Re: **Lake Chelan Hydroelectric Project No. 637-022**
Article 405 – Operations Compliance and Monitoring Plan
Article 401 – Quality Assurance Project Plan

OPERATIONS COMPLIANCE MONITORING PLAN

**LAKE CHELAN HYDROELECTRIC PROJECT
FERC Project No. 637**

QUALITY ASSURANCE PROJECT PLAN Lake Chelan Water Quality Monitoring and Reporting

Figure 3-2: Proposed Monitoring and Reporting Schedule

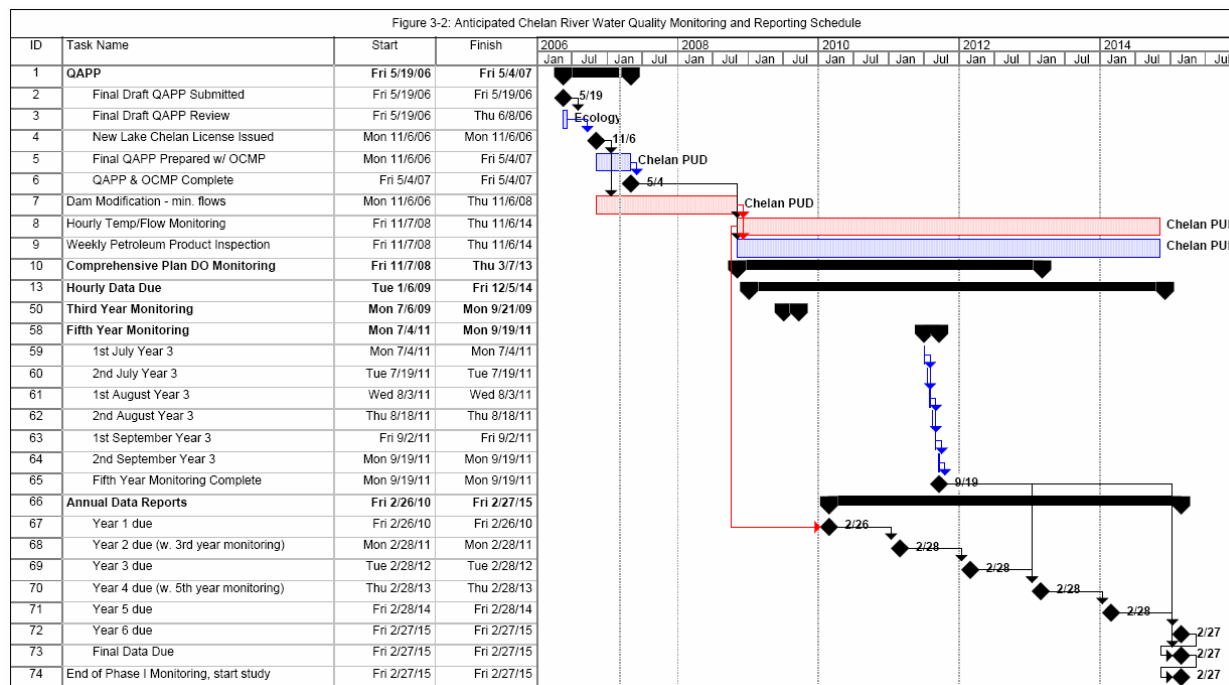
Page 11, Figure 3-2, Anticipated Chelan River Water Quality Monitoring and Reporting Schedule. Box no. 50 lists third year start and finish dates as 07/06/09 through 09/21/09, but no subsequent individual sampling dates within months. Box no. 58 lists fifth year start and finish dates. Boxes nos. 59 through 64 show six individual dates over July, August, and September. Individual dates within each of July, August, and September in Year 3 is desirable. Finally, boxes showing individual sampling dates in Year 5 are labeled Year 3 in the Task Name column, but by the year (2011) shown in the "Start" and "Finish" columns should be labeled Year 5.

Figure 5-1: Proposed Temperature Sampling Location, Forebay of the Lake Chelan Dam

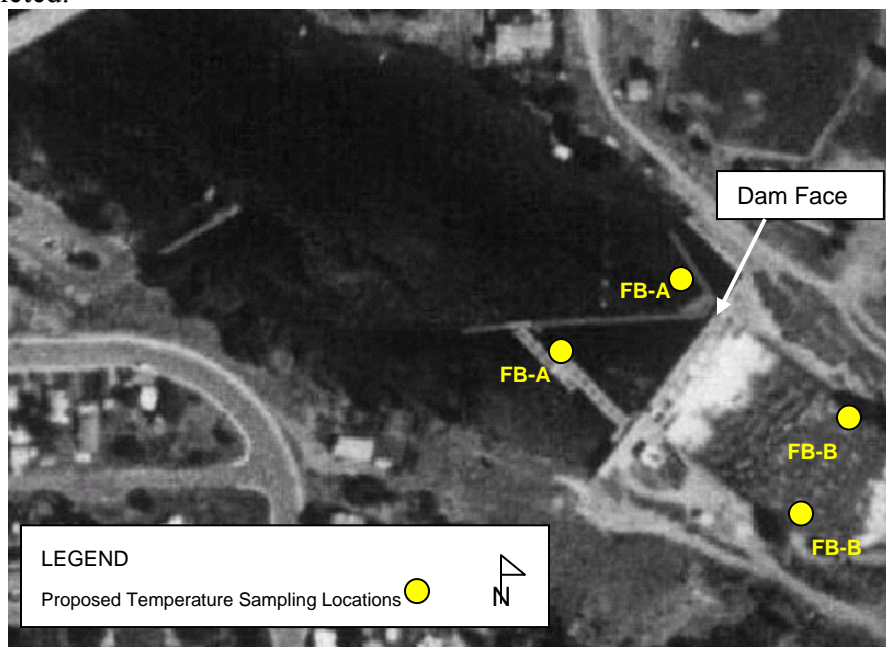
Page 18, Figure 5-1, Proposed Temperature Sampling Location, Forebay of the Lake Chelan Dam. I suggest different labeling for the sampling locations shown. For the two forebay sites shown (both FB-A), I suggest FB-L and FB-R (for Forebay-Leftbank and Forebay-Rightbank). For the dam tailrace, I suggest the non-specific FB-B and FB-B be changed to TR-L (Tailrace Left) and TR-R (Tailrace Right).

Figure 5-6: Proposed Turbidity, DO, pH Sampling Locations, Reach 4

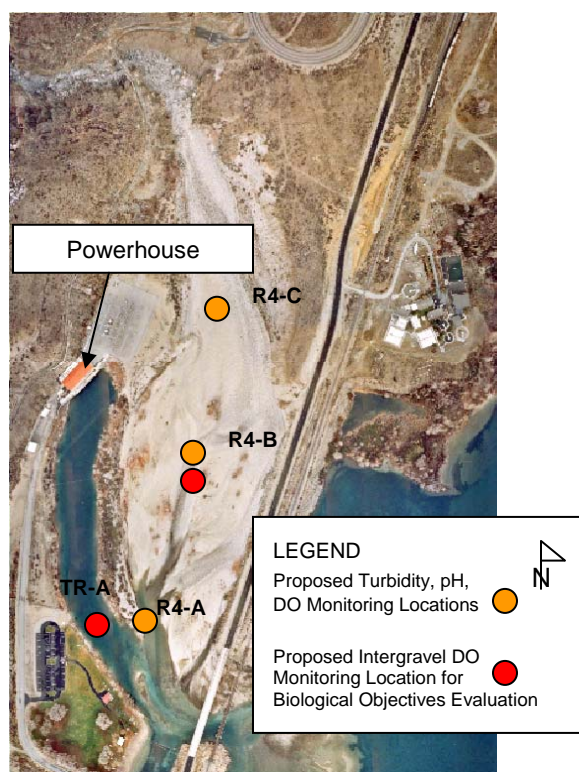
Page 20, Figure 5-6. Proposed Turbidity, DO, pH Sampling Locations, Reach 4. I recommend establishing additional intragravel monitoring stations close by R4-C and R4-A. The Habitat Channel will be approximately one-half mile in length. It would be prudent to monitor at the upper end, middle, and lower end what is occurring, especially DO levels, over this critical half mile.
